Subject: Minor Amendment to Valencia Crossing – TPC Project No: KBT-50

Subject: Valencia Crossing PAD Minor Amendment Request TPC Project No: KBT-50

NATIVE PLANT PRESERVATION PLAN The Reserve at Valencia Crossing

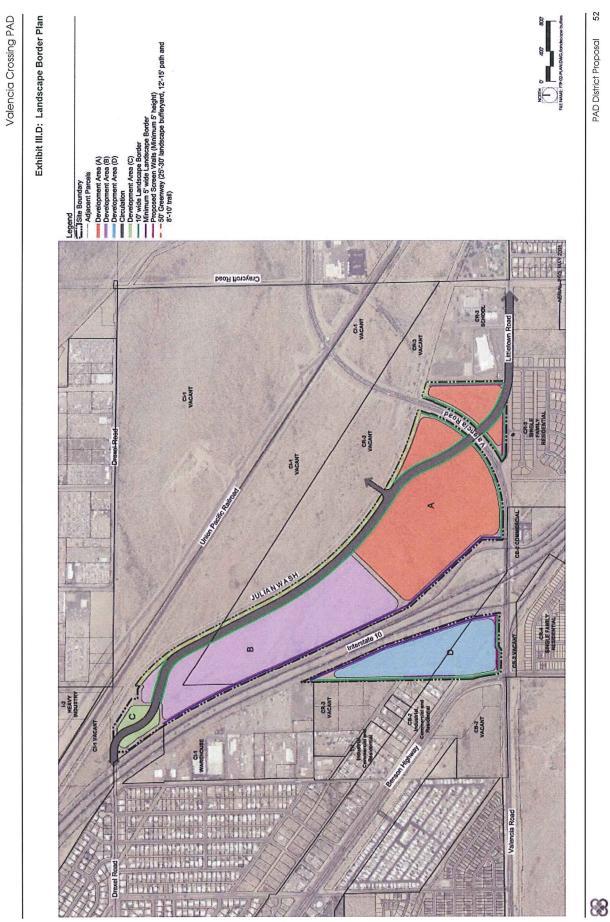
I am in support of your request for a plan amendment because requiring a 10' landscape border on the east boundary would result in a tunnel between the two uses, creating an unsafe situation, disregarding the principals of Safe by Design. (see drawing for illustration). Further, there are existing mature trees on the school's property along most of this boundary that provide visual relief. I recommend that the landscape required for this border be planted in a more appropriate location on the project site, including adding trees to the southeast (blue arrow).
